ADDENDUM NO. 01

February 14, 2024

**ZCS-ZCHS Stadium Locker Building & Concrete Repairs, ZMS Tennis Courts
and Eagle Elementary Building Demolition & Playground Renovation
1000 Mulberry St.
Zionsville, IN, 46077**

This Addendum consists of Pages ADD 1-1 through ADD 1 - 3 and attached Addendum No. 1 from Fanning Howey dated February 14, 2024 for **Zionsville High School 223139.00** consisting of 5 pages, specification section 10 14 23.16 – Interior Panel Signage, and 29 Drawings. **Eagle Elementary 223135.00** consisting of 1 page and 2 Drawings, and **Zionsville Middle School 223144.00** consisting of 1 page and 2 Drawings.

ZCHS Site Logistics Plan

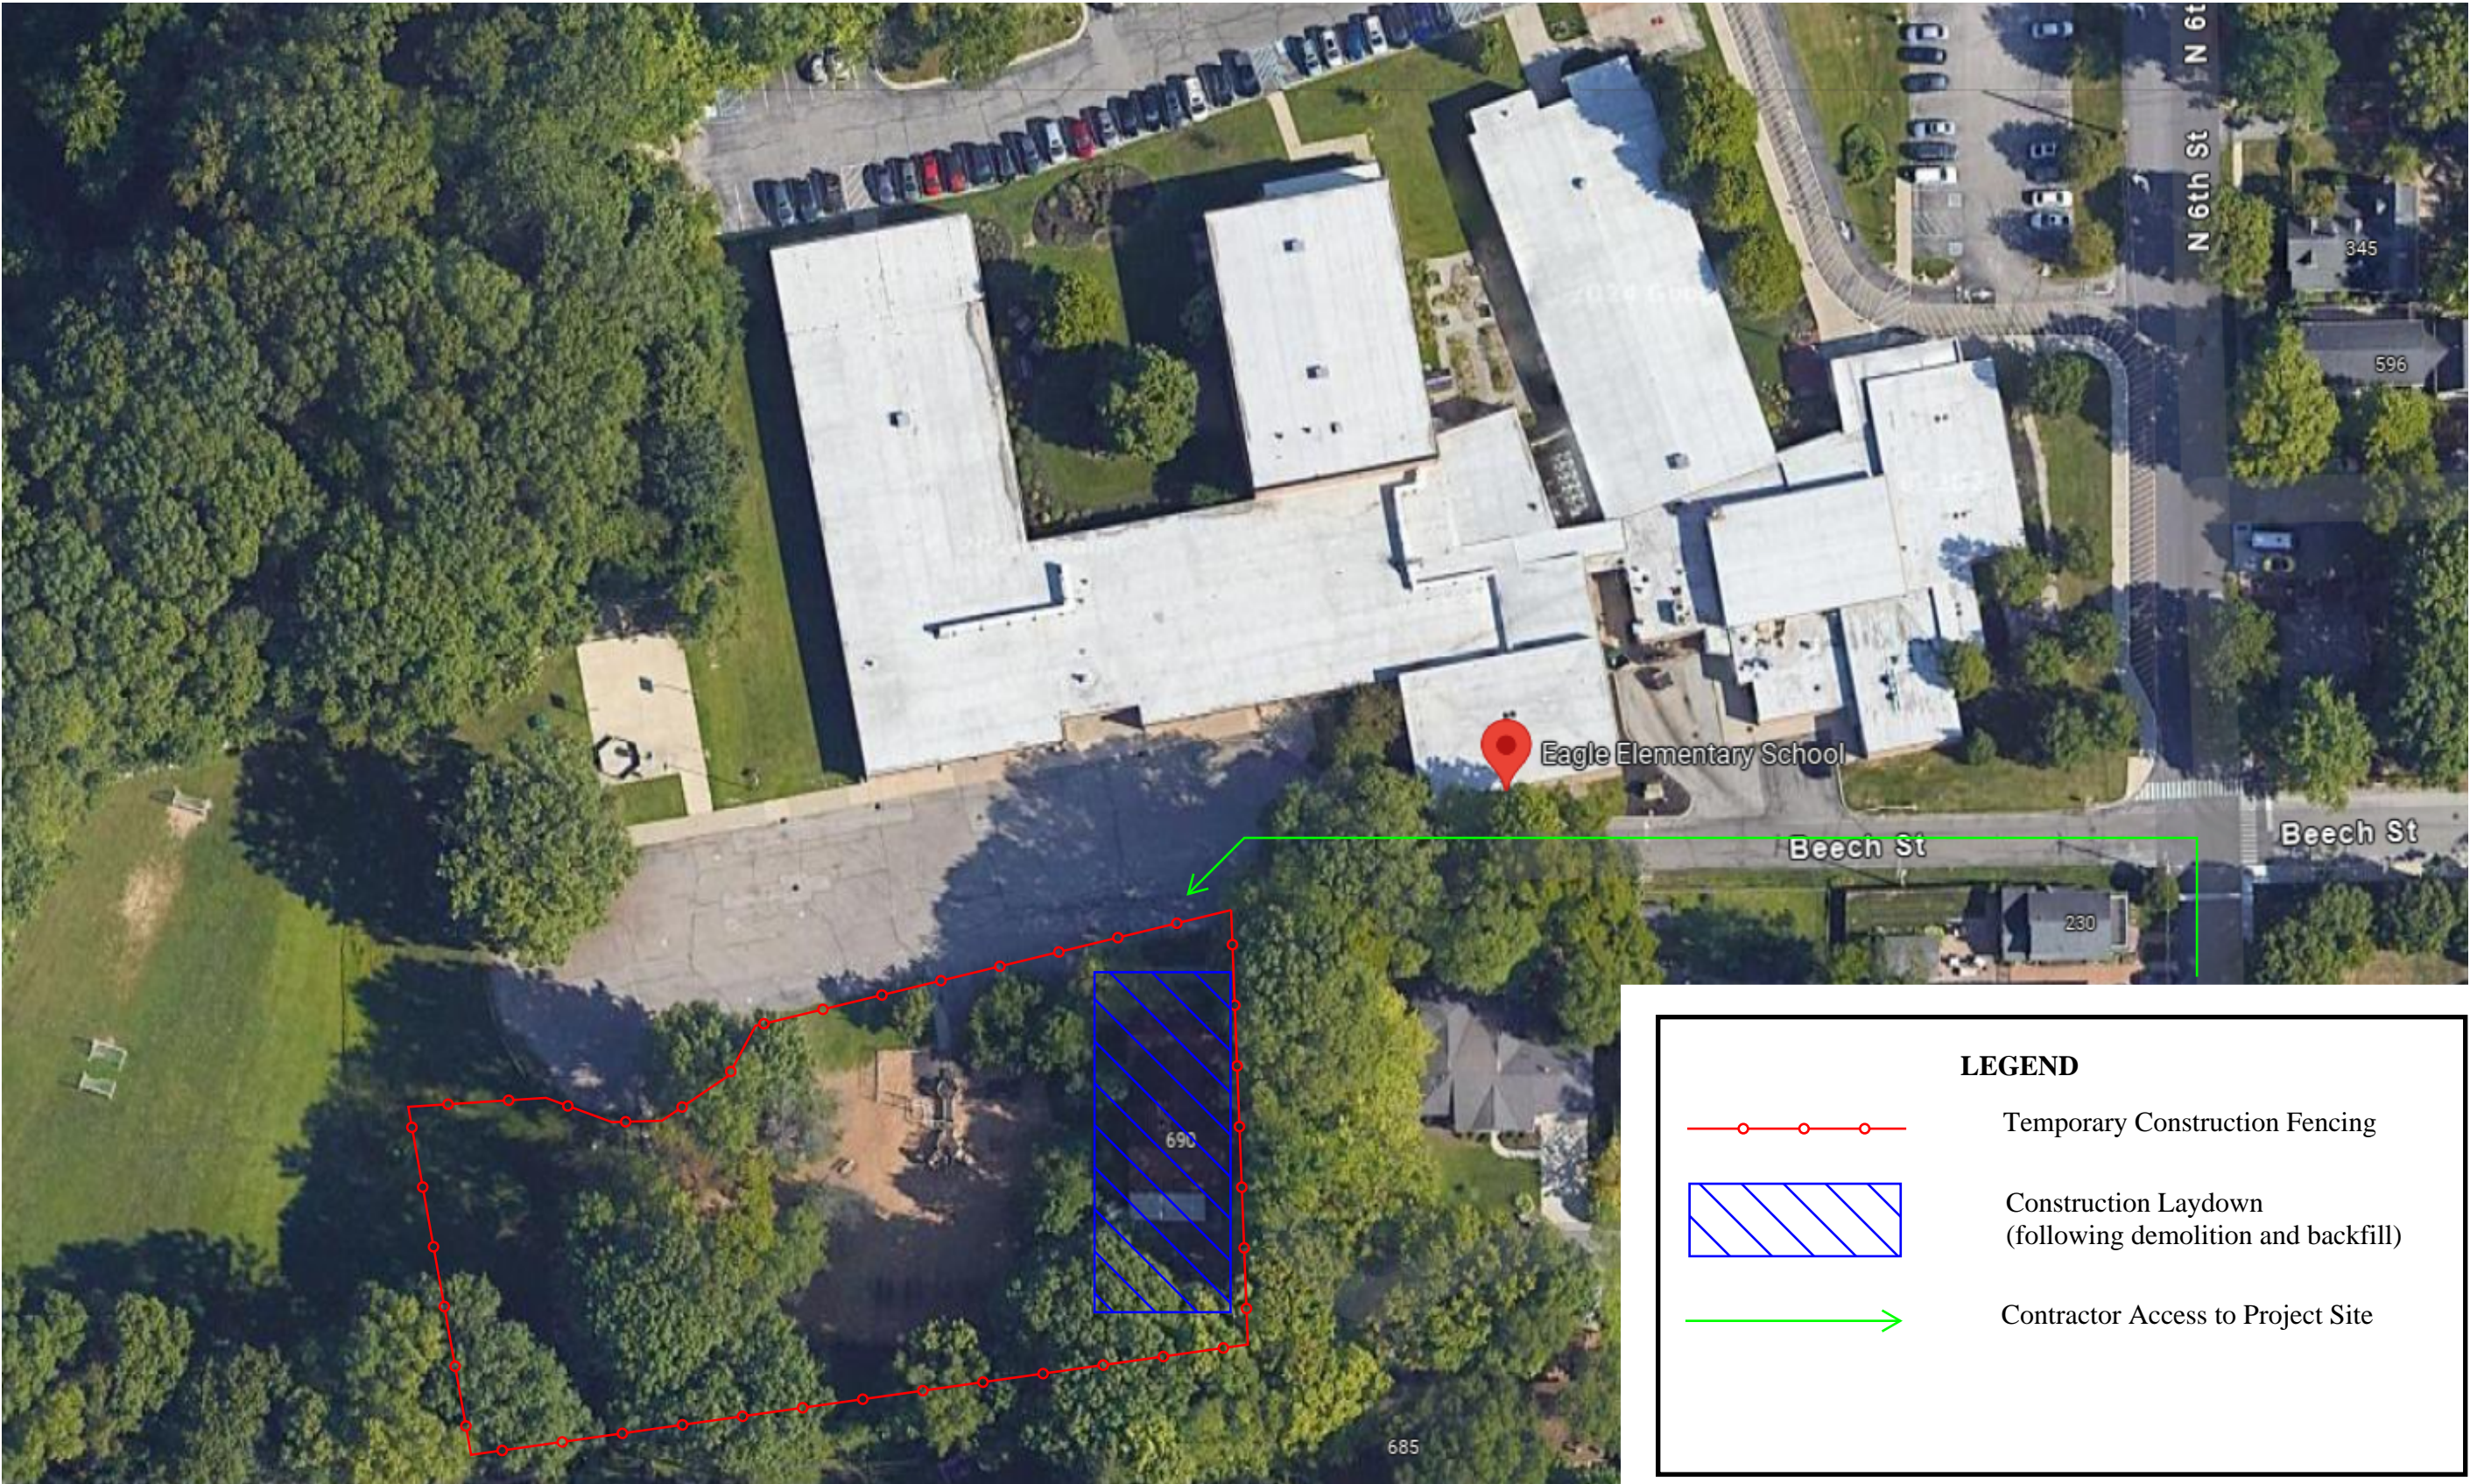
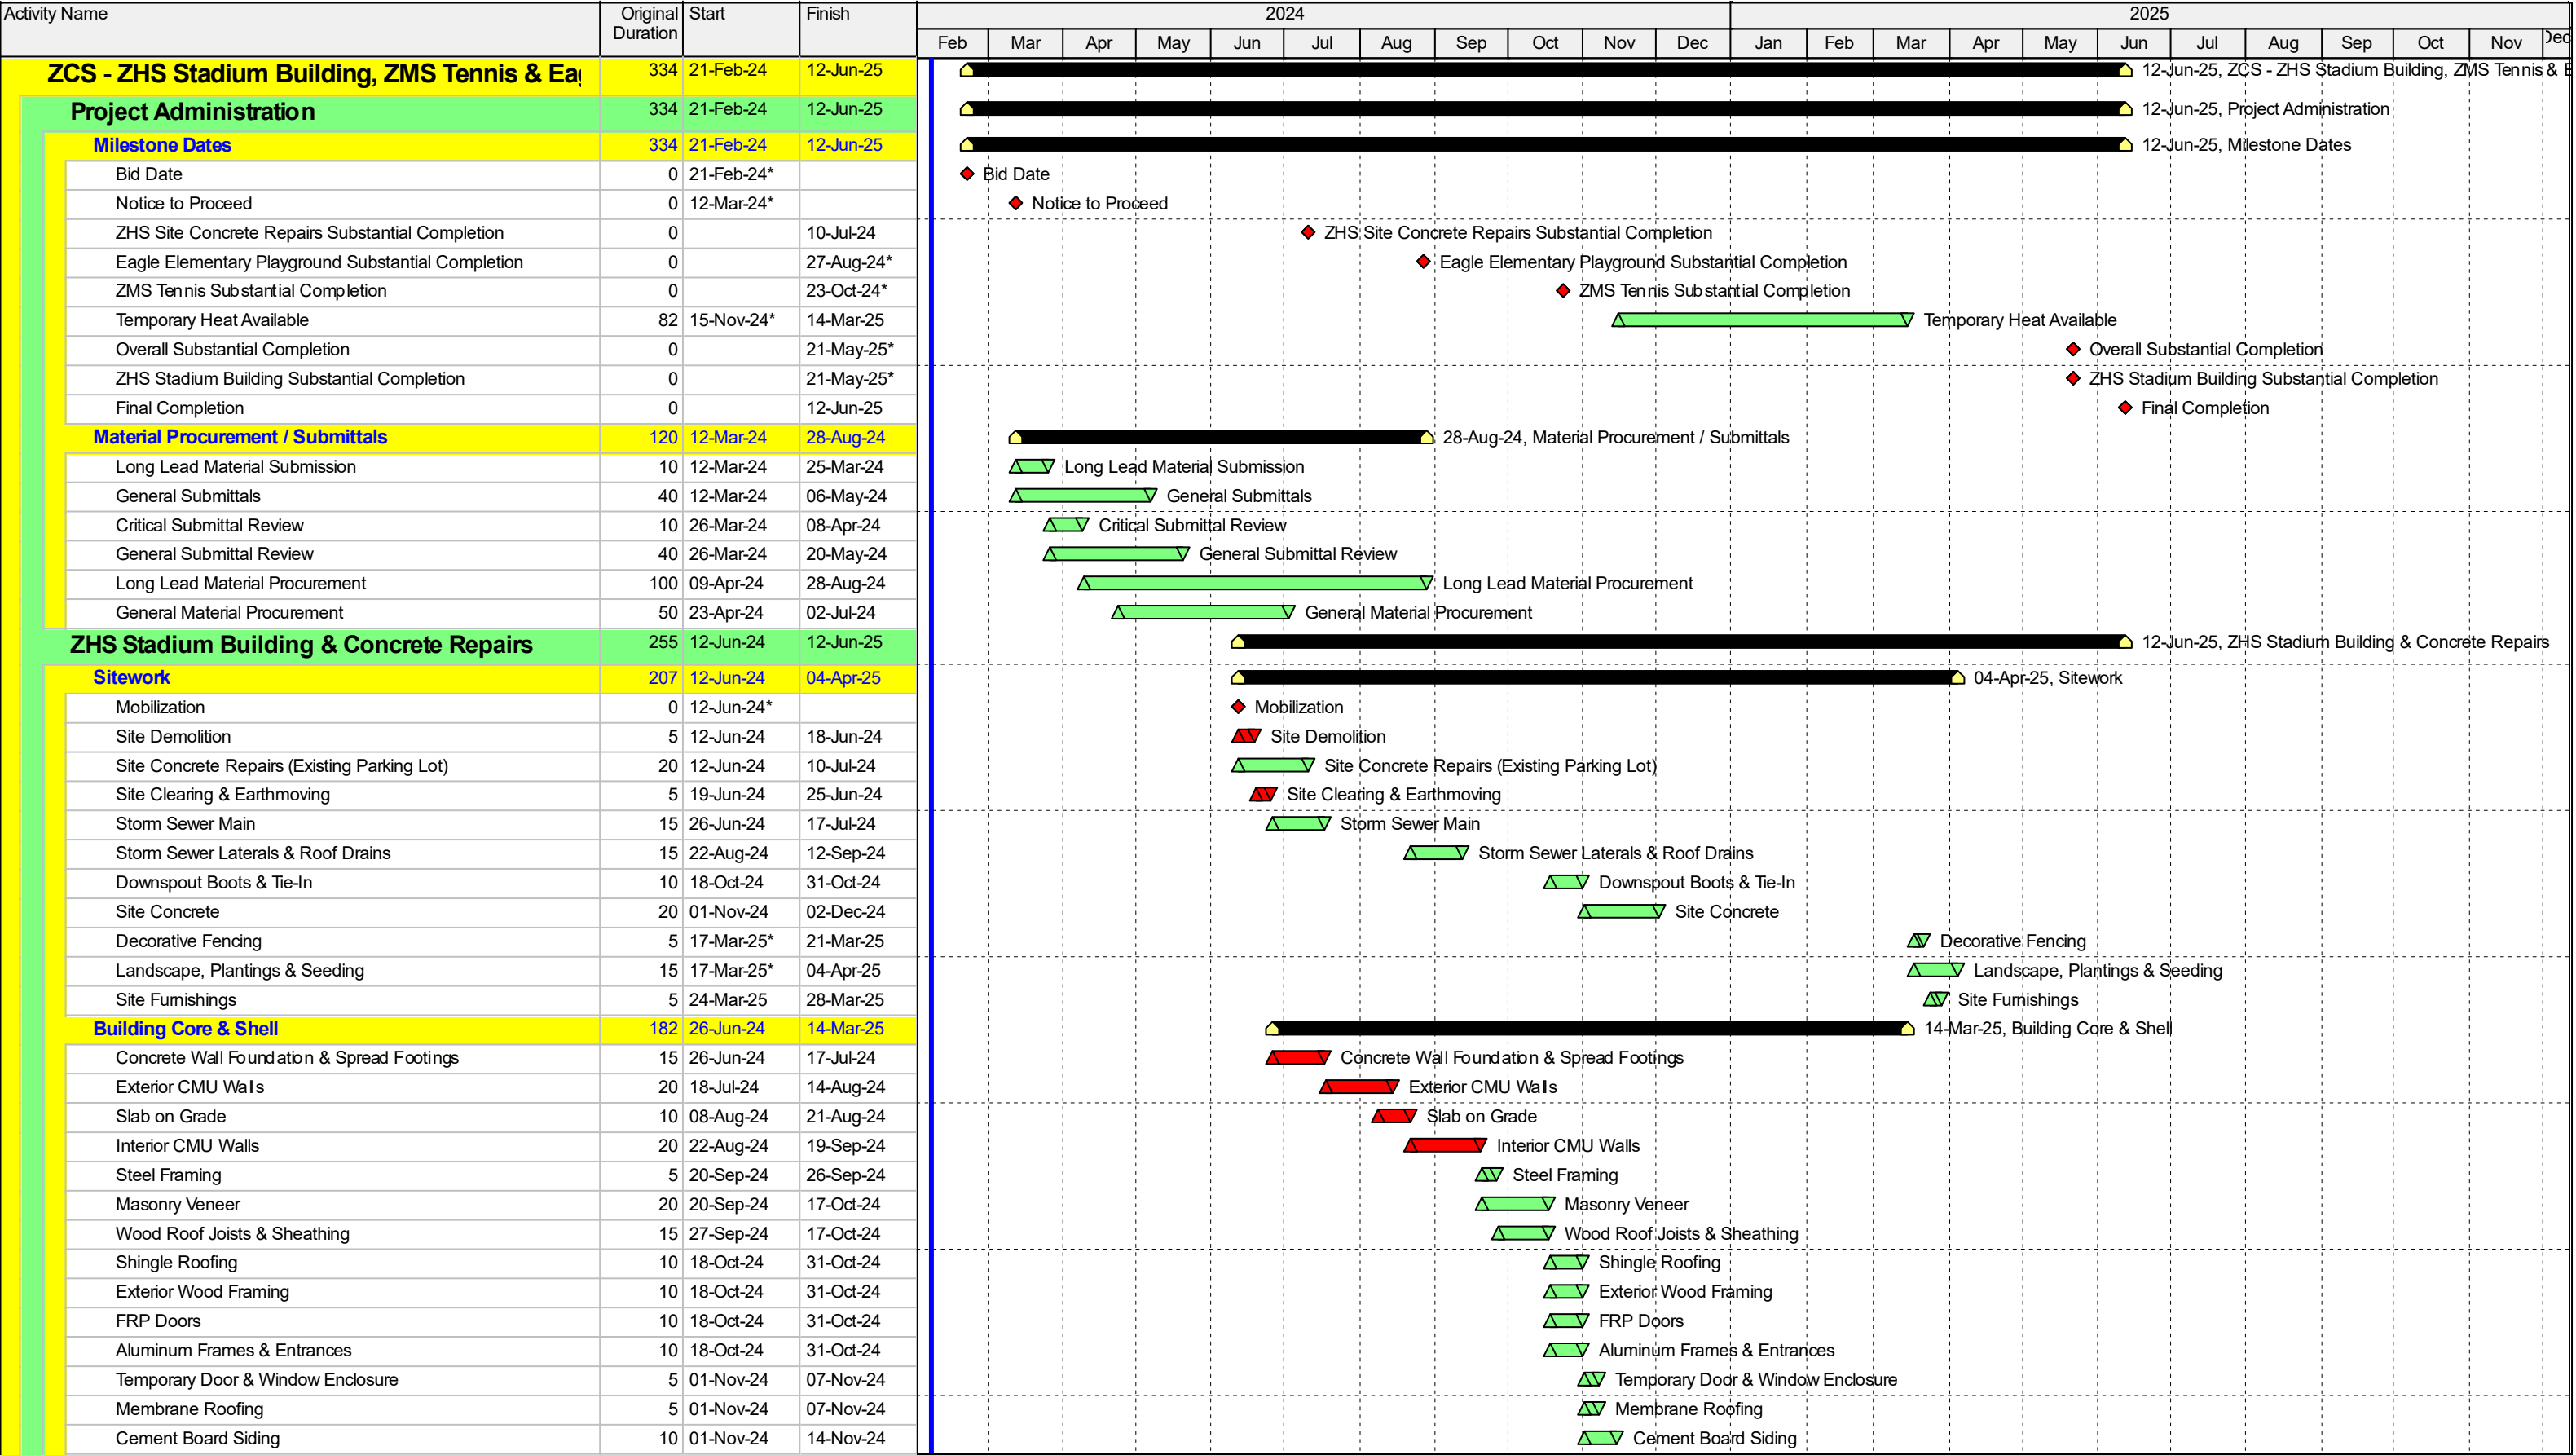
Remove and Replace
Section of Existing
Fence. Provide
double swing gate
with securable lock.

Temporary Stone Access Drive. 12" thick,
composed of 8" #8 stone and 4" #53 stone.
Intended for equipment and delivery access.

Temporary Contractor Parking and Laydown.
8" thick composed of #53 stone.

Prohibited Contractor / Equipment Delivery.
Not parking, staging or delivery in this area
at any time.
